METROPOLITAN DEVELOPMENT COMMISSION
REGIONAL CENTER HEARING EXAMINER

STAFF REPORTS FOR APRIL 14, 2016

Case Number	2016-REG-026
Address (approx.)	16 East Henry Street
Location	Center Township, Councilmanic District # 16
Petitioner	Shawn Cannon
Zoning	CBD-2 (RC)
Request	Regional Center Approval to provide for a hotel, with retail space and a parking garage.

Site plan – 2016-REG-026

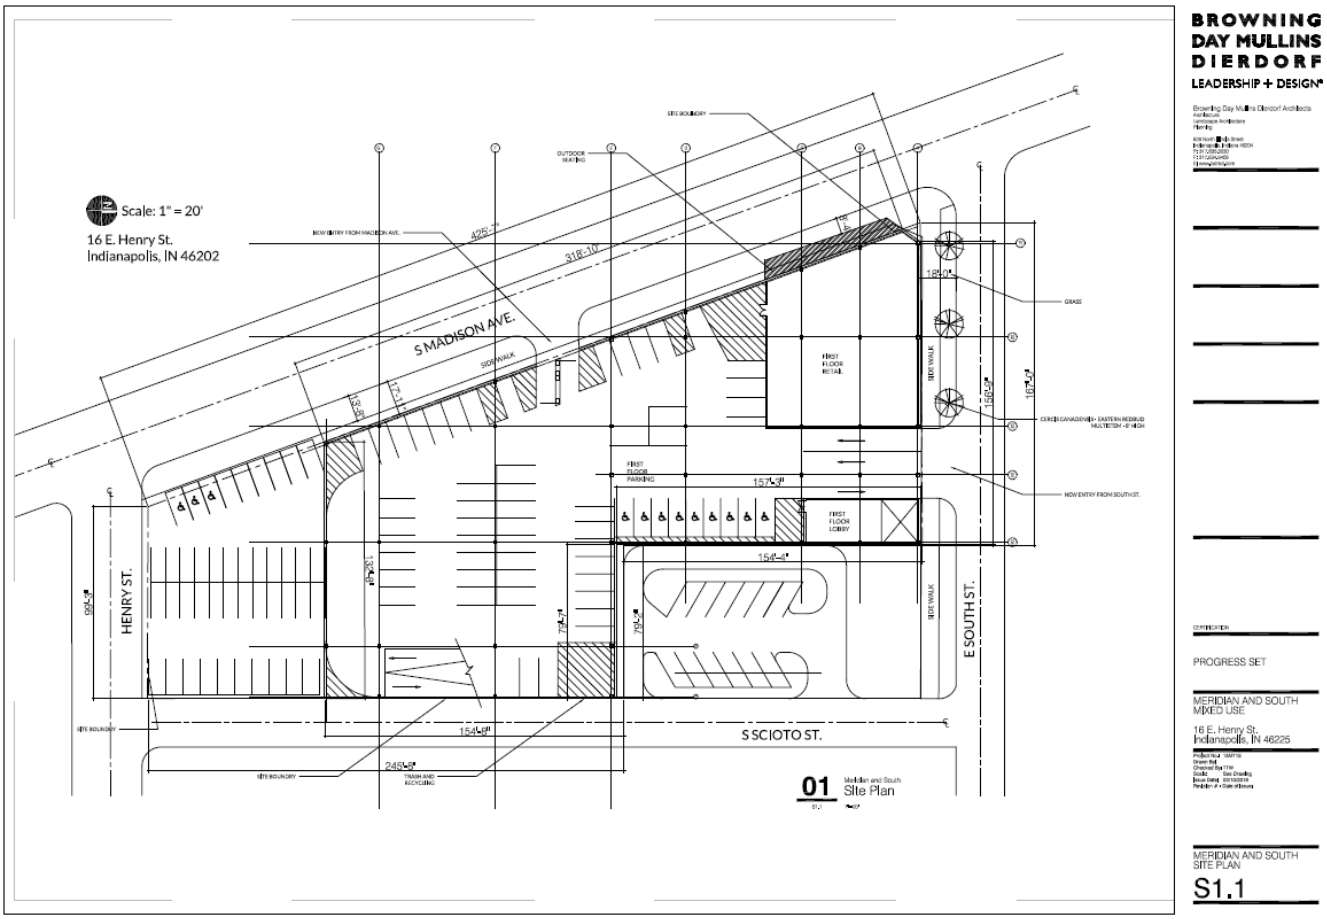
6. The site plan indicates that a portion of the existing surface parking lot would remain. However, the plan indicates that some parking spaces are located within the public right-of-way. Guidelines SC 3.4.1, SC 3.4.2 and CA 4.4.3 require surface parking lots to be screened along pedestrian ways, with at least four feet of landscaping. Since the development of this lot would not occur with this request, staff would not require that these Guidelines be met; however, the spaces must be removed from the public right-of-way, or a variance of development standards granted.
7. Bicycle parking is required for commercial developments of more than 50,000 square feet (CA 4.2.2). These spaces are encouraged to be adjacent to, or accessible, from the sidewalk (CA 4.2.1). The petitioner did not address this issue in the submittal.

East Elevation 1"=20'-0"

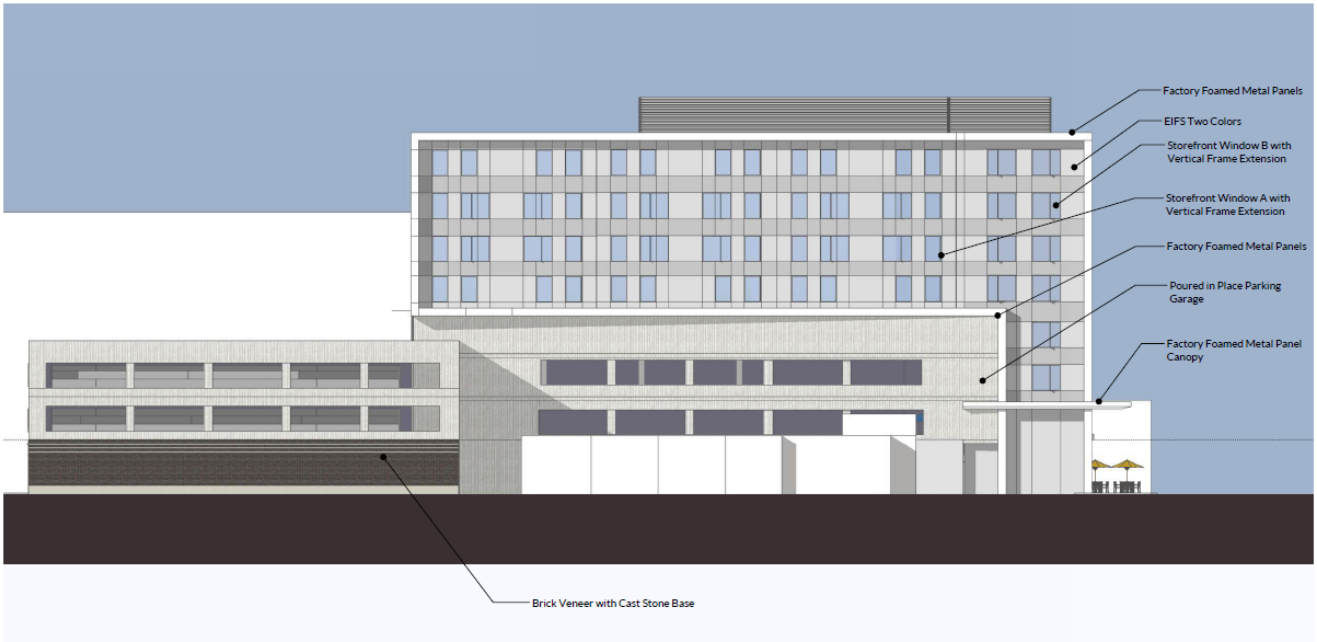
3. The proposed east and south elevations include large areas on the first floor constructed of brick masonry and concrete. These areas would each be more than 30 linear feet in length. Guideline CA 2.1.6 requires that visual interest be incorporated into these areas through "landscaping, lighting features, public art, windows or cutouts" to create interest. The petitioner did not address this issue in the submittal.
